**RE: Tulas**  
**8100 Wyoming Blvd**  
**Engineer's Stamp Date: 12/20/2021**  
**Hydrology File: C19D011D6**

Based upon the information provided in your submittal received 10/21/2021, the Grading & Drainage Plan is approved for Building Permit. Please attach a copy of this approved plan in the construction sets for Building Permit processing along with a copy of this letter.

**CITY OF ALBUQUERQUE  
PLANNING DEPARTMENT  
HYDROLOGY DEVELOPMENT SECTION**

**WAIVER APPLICATION FROM STORMWATER  
QUALITY VOLUME MANAGEMENT ON-SITE**

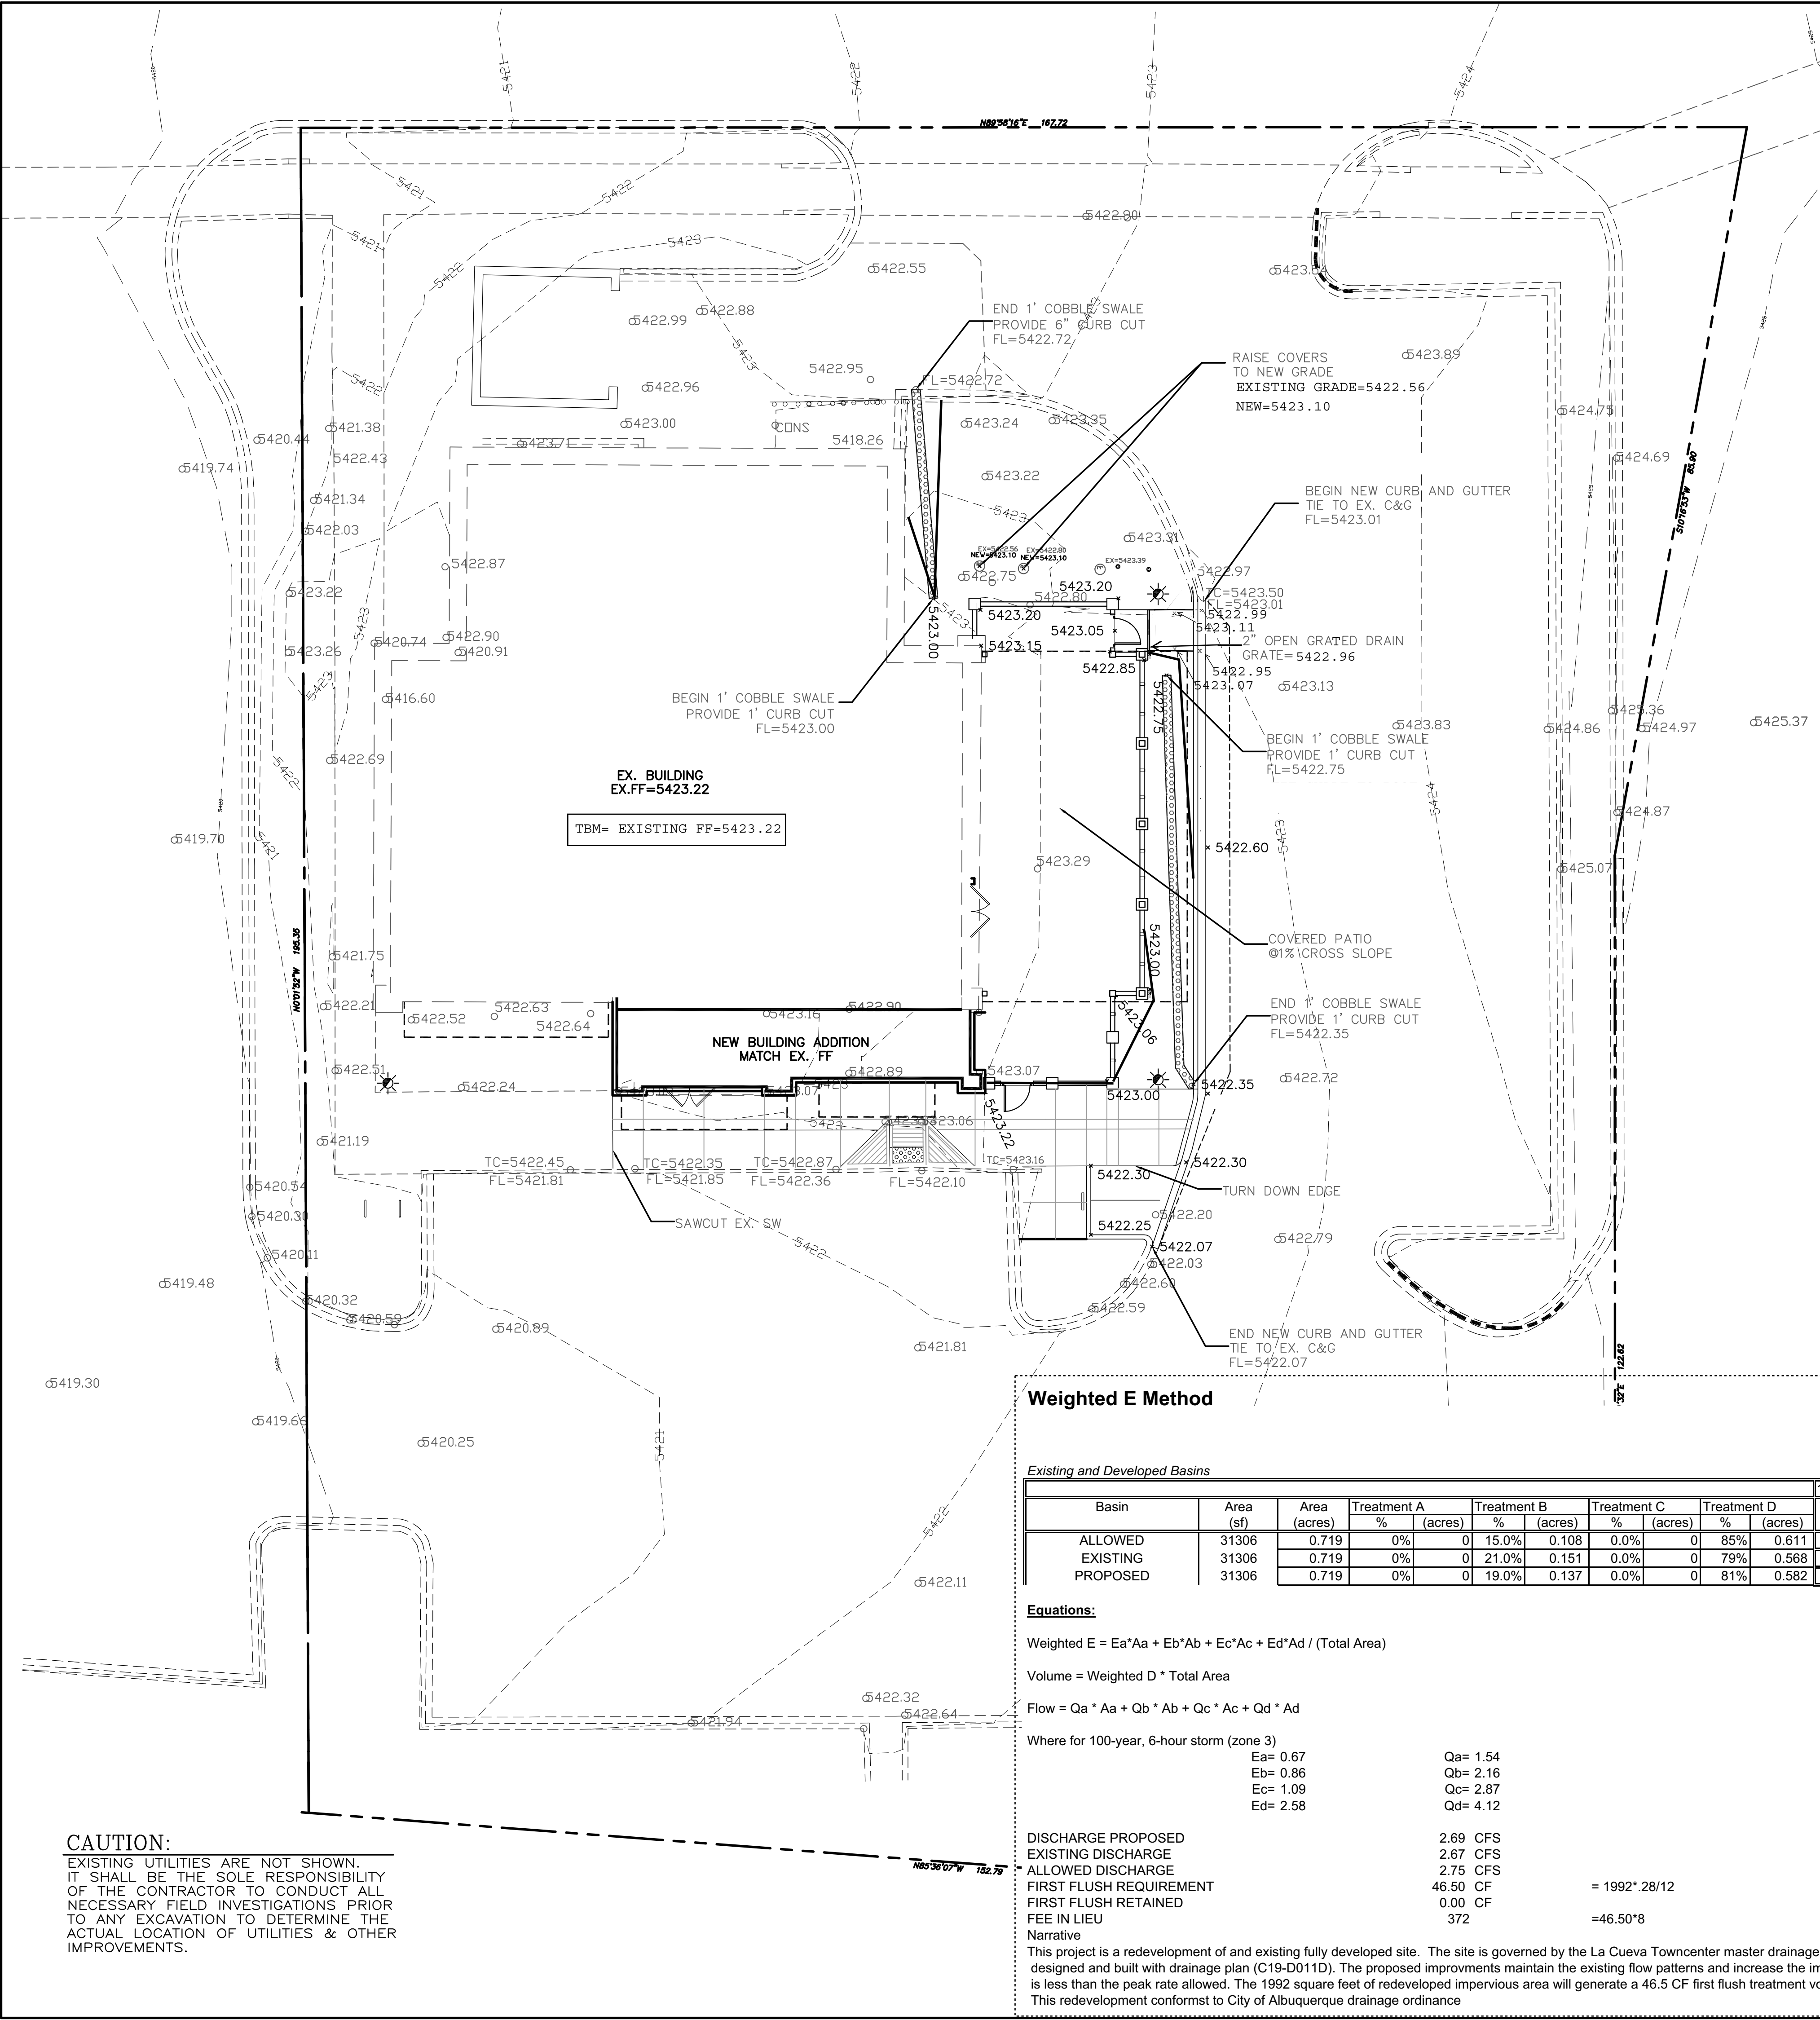
1. Engineer's Certification, per the DPM Part 6-14 (F): *Engineer's Certification Checklist For Non-Subdivision* is required.

2. Payment in Lieu amount of \$372.00 must be paid using the attached treasury deposit slip to Shannon Cordero ([sdcordova@cabq.gov](mailto:sdcordova@cabq.gov)).
